P.U.D. STAFF REPORT – CITY OF SHREVEPORT

CASE NUMBER 22-16-C: PLANNED UNIT DEVELOPMENT (PUD) & PRELIMINARY SITE PLAN

Re: PUD Application for Stevens Landing Subdivision and Townhouse Development

STEVENS LANDING SUBDIVISION
 STEVENS ROAD
 SHREVEPORT, LA

LOT LAYOUT W/TOWNHOMES-30'X70' (DUPLICATE)

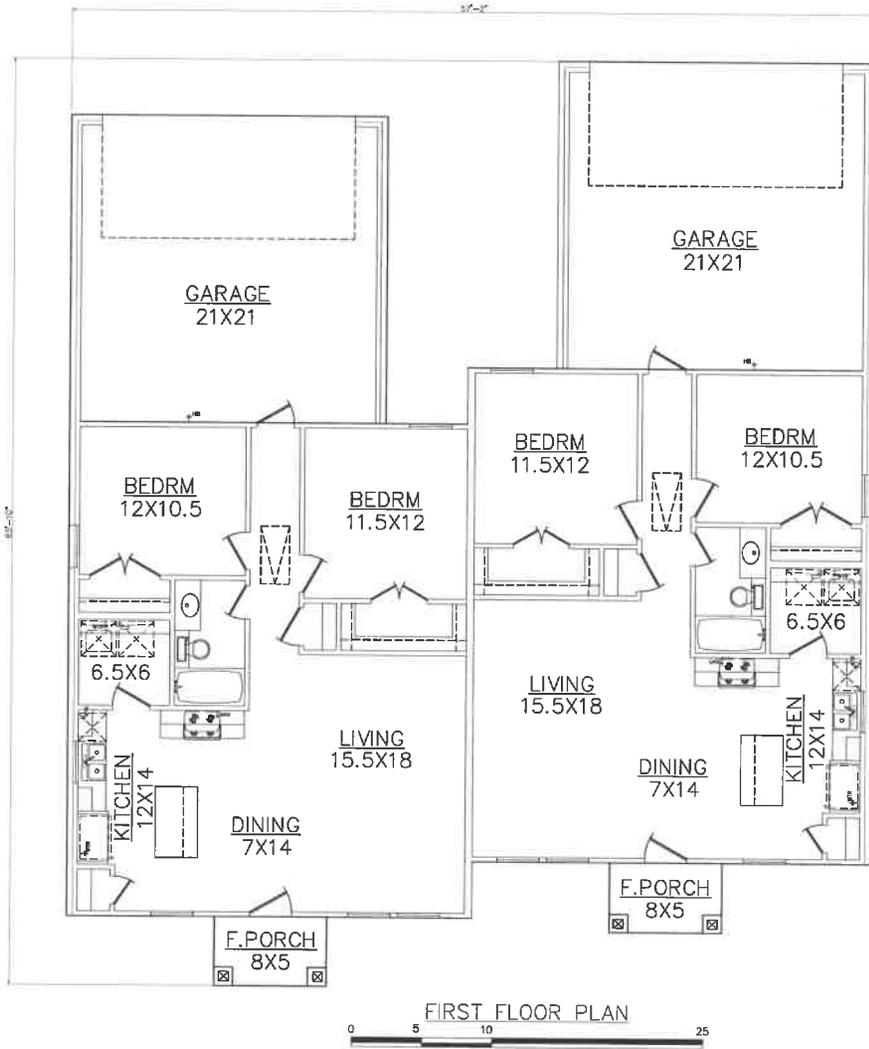
The proposed site plan has been reviewed by City Engineering, Public Works, Water & Sewerage, and Fire Prevention. Fire Prevention notes that the 15'-wide entrance to the north of the median is too narrow for emergency vehicles and must be widened to a minimum of 20 feet. If the PUD is approved, this would be noted as a stipulation and a revised site plan showing the change would

need to be submitted to the MPC Executive Director for approval. The site plan also shows a 695'-long street ending in a cul-de-sac which, per UDC Section 12.1.B.3.b requires City Engineer approval because it is longer than 600 feet. In evaluating this case, the City Engineer stated that any potential cul-de-sac issues would be related to MPC requirements, rather than Engineering requirements, and will concur with MPC recommendations in this regard. MPC Staff has no concerns about the longer cul-de-sac and recommends approval.

1. A revised plan showing the entrance to the north of the median widened to a minimum of 20 feet must be submitted to the Executive Director for review and approval prior to obtaining permits.
